SUBJECT: NuScale Power, LLC Response to NRC Request for Additional Information (RAI No. 9936) on the NuScale Topical Report, "Rod Ejection Accident Methodology," TR-0716-50350, Revision 2

Response to Request for Additional Information

RAI No.: 9936

NRC Question No.: NTR-01

Figure 6-1 Power response at 55 percent power, end of cycle

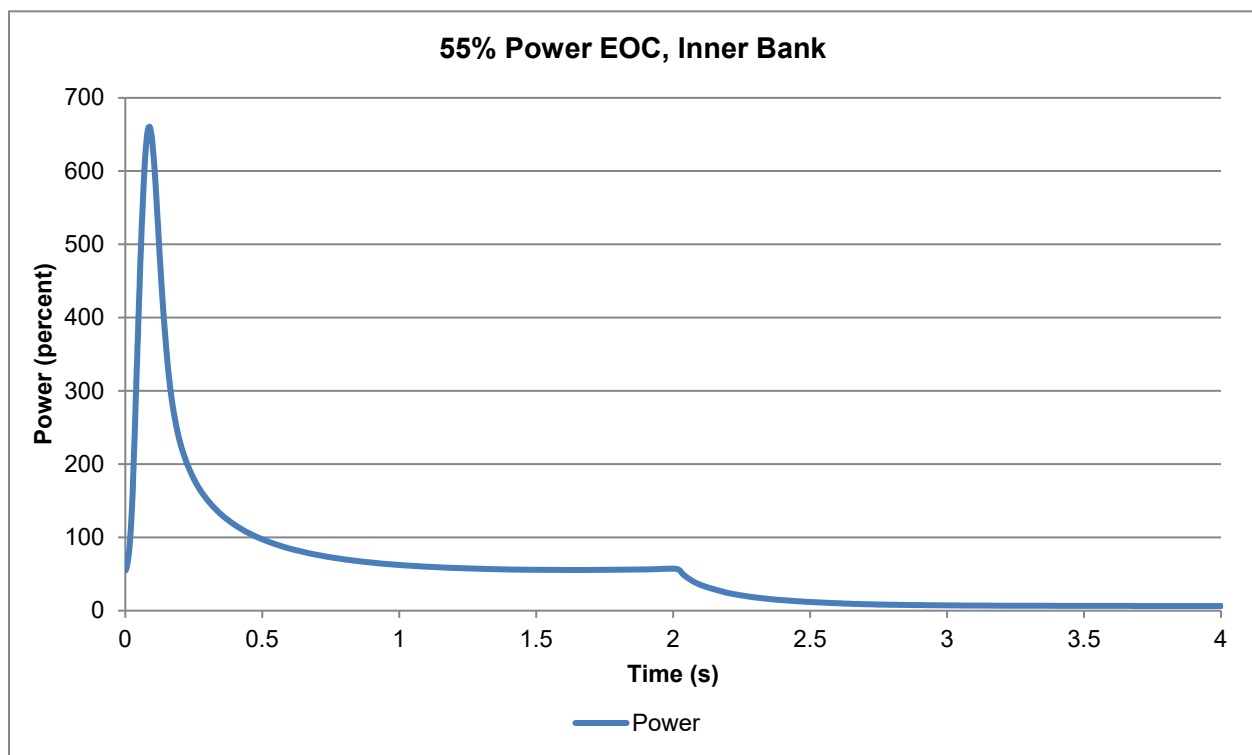
Section 5.1.2 of TR-0716-50350, Rev 2, states the REA is analyzed at BOC and EOC burnups to bound core reactivity conditions and the expected limiting MCHFR case will occur at EOC. Middle of cycle (MOC) conditions are not explicitly considered, and no justification is provided for the statement that EOC is limiting. Consistent with RG 1.236, the REA method should address the full spectrum of cycle burnup and range of power operation, which includes consideration of all MOC conditions.

To support a finding that the REA analysis is appropriately bounded, the staff requests that the TR be updated to include consideration of the full spectrum of cycle burnup and range of power operation in the set of initial conditions for the REA analysis, or provide justification for excluding MOC conditions from these initial conditions.

The REA is analyzed at BOC, MOC, and EOC burnups to bound core reactivity conditions. ~~For prompt critical CRA ejections,~~ it is expected that the limiting MCHFR case will occur at EOC because the delayed neutron fraction is minimized at this time, and a smaller delayed neutron fraction ~~increases the reactivity insertion for CRA ejection and~~ typically maximizes the ~~dynamic response~~ peak power of the event for a given initial power level. For sub-prompt critical jumps, the limiting MCHFR may not be associated with the maximum peak power.

Figure 6-1 shows an example of the power response at 55 percent and EOC, which is the highest power case of an example core design and operational limits. The large CRA worth, which is effectively a prompt critical reactivity insertion, results in a rapid power increase. This power increase is quickly turned around by the negative MTC and DTC feedback. The reactor trip signal is given early in the transient, as soon as the two operating detectors show a 15 percent power increase, and a delay of two seconds is assumed. After the large, narrow pulse, with a pulse width at half height of 0.12 seconds, a nearly steady state power of around 56 percent is reached due to the uncertainty treatment until the CRAs start moving.
